Building Permit Application

Permit No.: B16002618

Amendment, Permit # B16002618

Shaw Residence
 PROPOSED ADDITION
 14975 Old Frederick Road, Woodbine, MD 21797

FLOOR PLANS

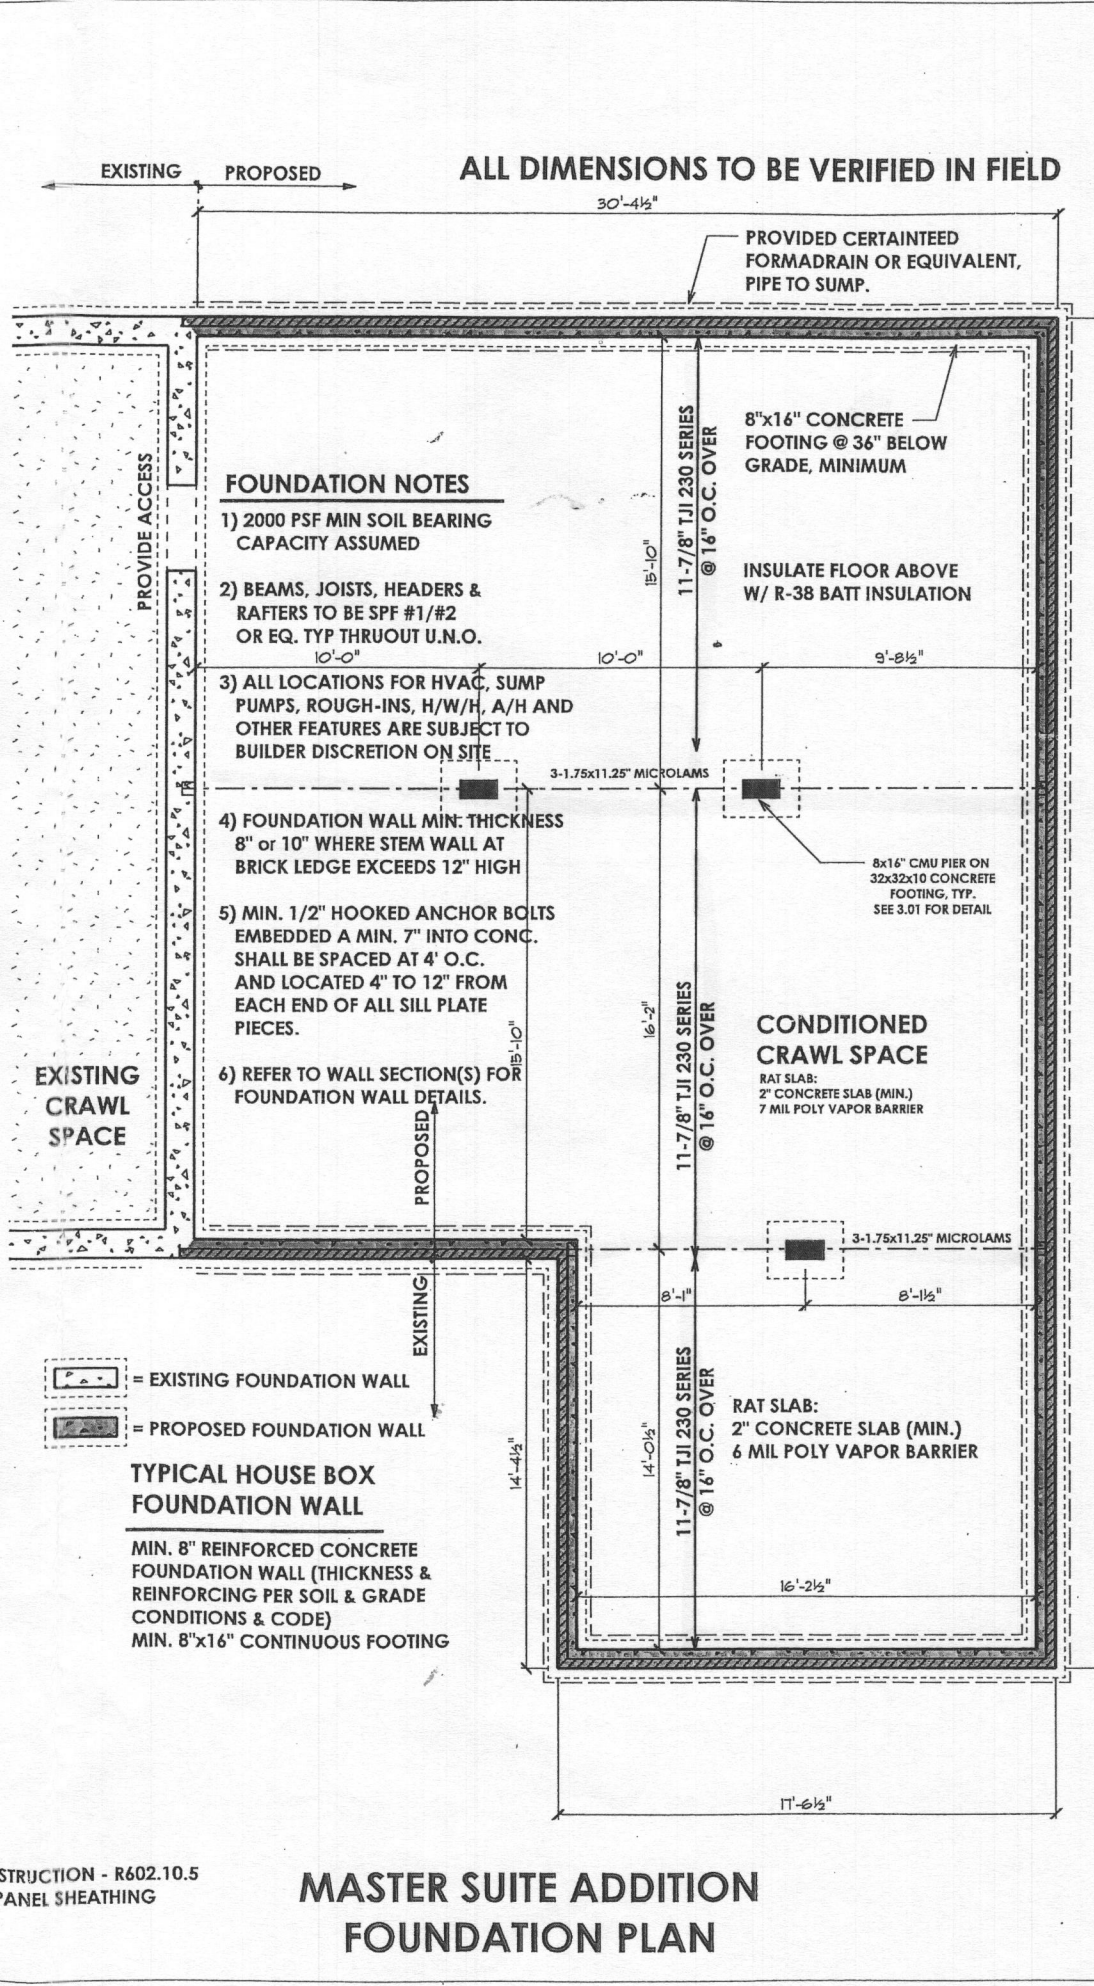
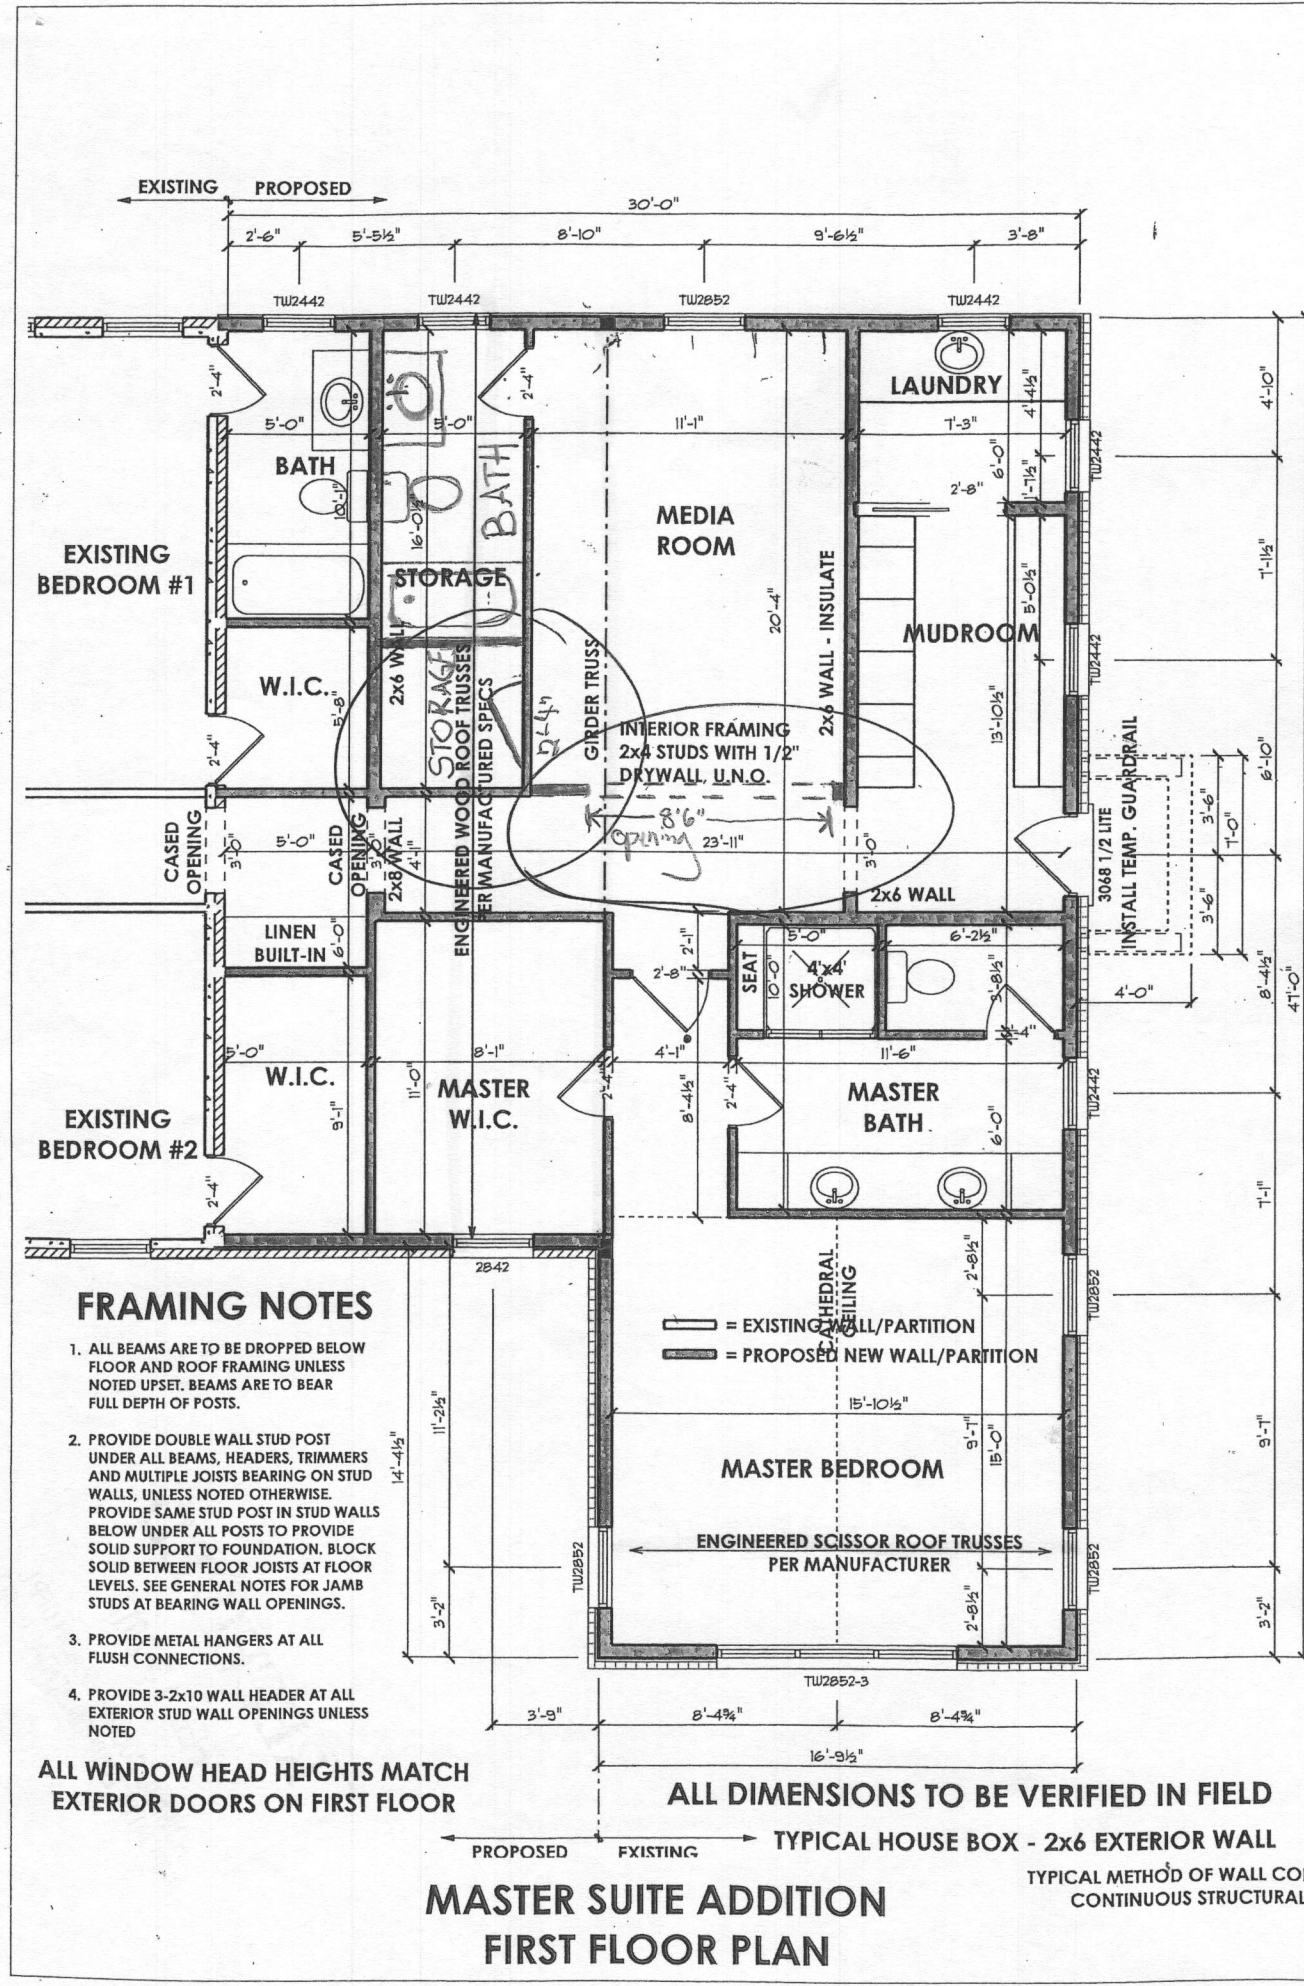
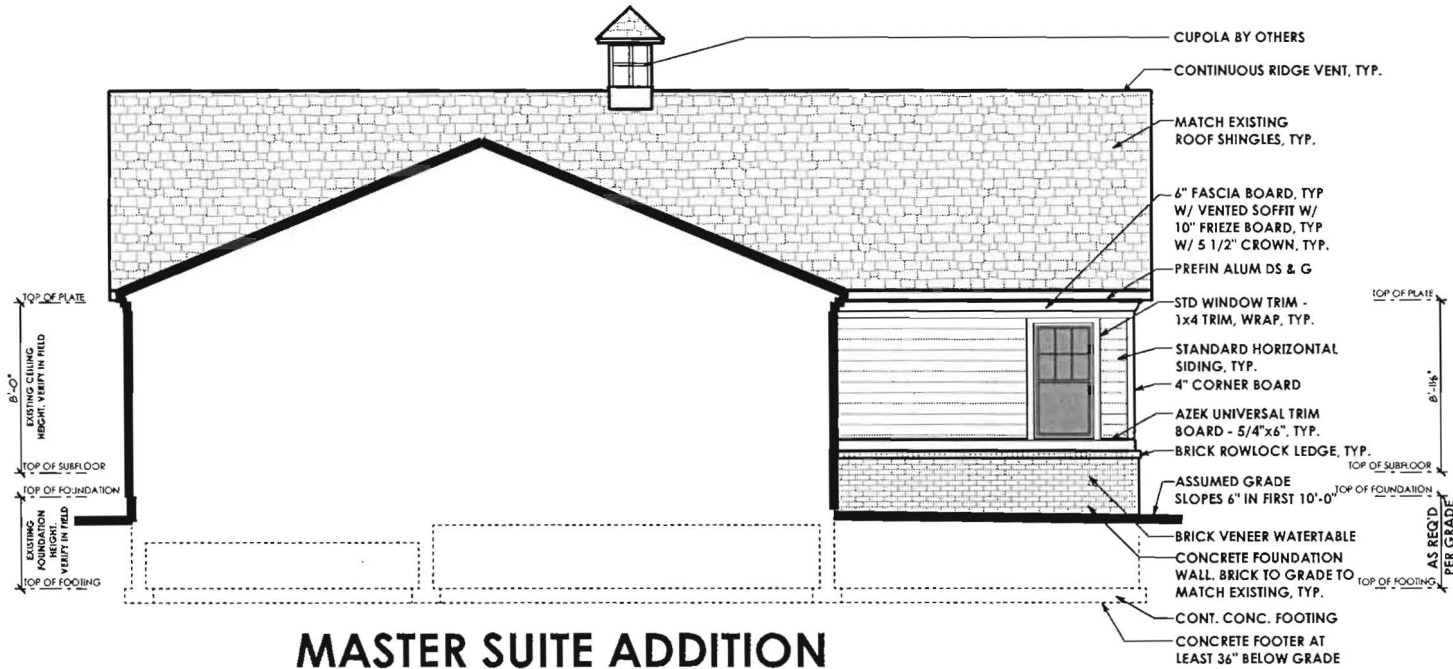
I am requesting to amend Permit # B16002618 at
14975 Old Frederick Rd. Woodbine, MD 21797 to
add door to storage rm. and shortening opening to
8'6" on opening for media room (media rm. entry)

ADD DOOR TO STORAGE ROOM
 + DECREASE SIZE OF OPENING
 TO MEDIA ROOM
